UNITED STATES PATENT AND TRADEMARK OFFICE

APPLICATION NO.	FILING DATE	FIRST NAMED INVENTOR	ATTORNEY DOCKET NO.	CONFIRMATION NO.
10/524,676	10/13/2005	Jens Otterbach	10191/3724	1465
26646	7590	09/21/2006	EXAMINER	
KENYON & KENYON LLP ONE BROADWAY NEW YORK, NY 10004			LAU, TUNG S	
			ART UNIT	PAPER NUMBER
			2863

Office Action Summary	Application No.	Applicant(s)	
	10/524,676	OTTERBACH ET AL.	
	Examiner	Art Unit	
	Tung S. Lau	2863

DETAILED ACTION

FIG 1

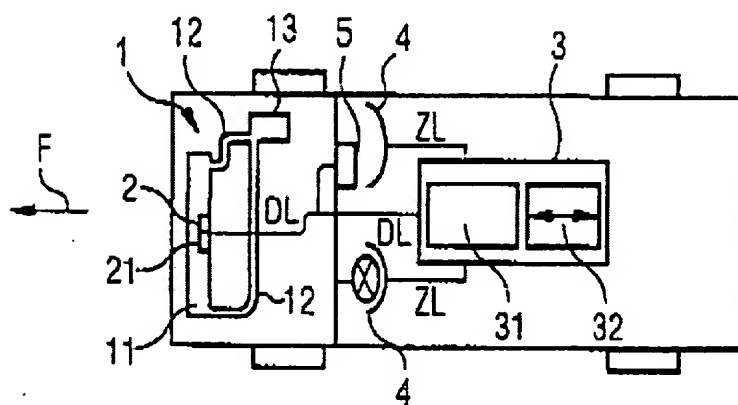
Grosshauser and Lorenz Pfau disclose a device (fig. 1) for impact sensing (page 2, lines 21-24), comprising: at least one pressure sensor (fig. 1, unit 2) to provide a signal; and a processor (fig. 1, unit 31) connectable to the at least one pressure sensor (fig. 1, unit 2) so that the processor performs the impact sensing as a

Regarding claim 12, Grosshauser and Lorenz Pfau further disclose at least one pressure sensor (fig. 1, unit 2) is arranged in a largely enclosed part (fig. 1, unit 12, mount inside the radiator), and the additional sensor is arranged outside of the largely enclosed part (page 4, lines 14, additional side impact sensor on the door also can be use outside of the radiator).

Regarding claim 13, Grosshauser and Lorenz Pfau further disclose a memory to supply the ambient pressure (fig. 1, unit 2, 31, microprocessor has memory to do calculation on fig. 2).

Regarding claim 15, Grosshauser and Lorenz Pfau further disclose at least one pressure sensor (fig. 1, unit 2) is configured to normalize the signal (page 6, lines 3-22, fig. 2).

Regarding claim 16, Grosshauser and Lorenz Pfau further disclose the processor (fig. 1, unit 31) is configured to normalize the signal (page 6, lines 3-22, fig. 2).

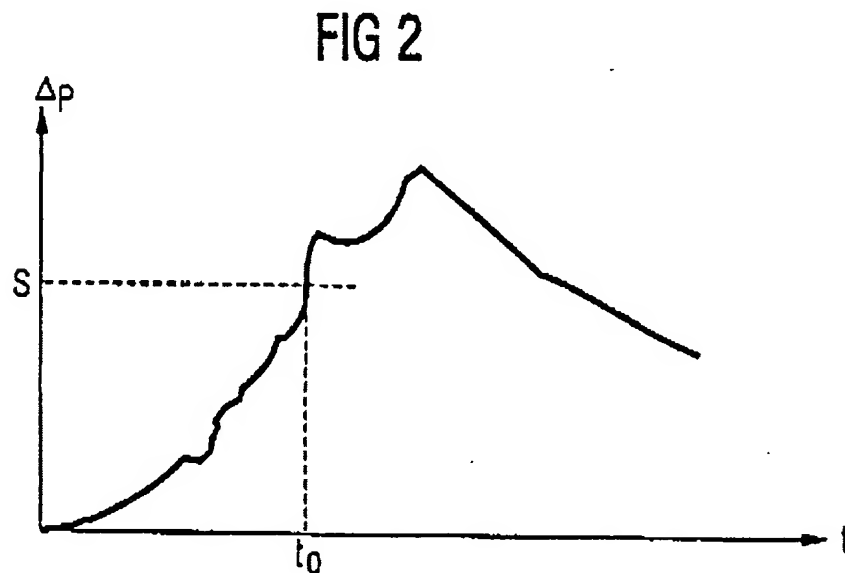
function of the signal (page 7, lines 9), wherein the signal is preprocessed (page 6-7, lines 23-2) so that the signal is normalized to a predefined pressure (page 8, lines 1-13, fig. 2).

Regarding claim 10, Grosshauser and Lorenz Pfau further disclose the signal is normalized to an ambient pressure (page 6, lines 12-22, fig. 2).

Regarding claim 14, Grosshauser and Lorenz Pfau further disclose at least one pressure sensor includes a sensor element (page 6, lines 3-12) configured to emit the normalized signal (page 6, lines 12-22, fig. 2).
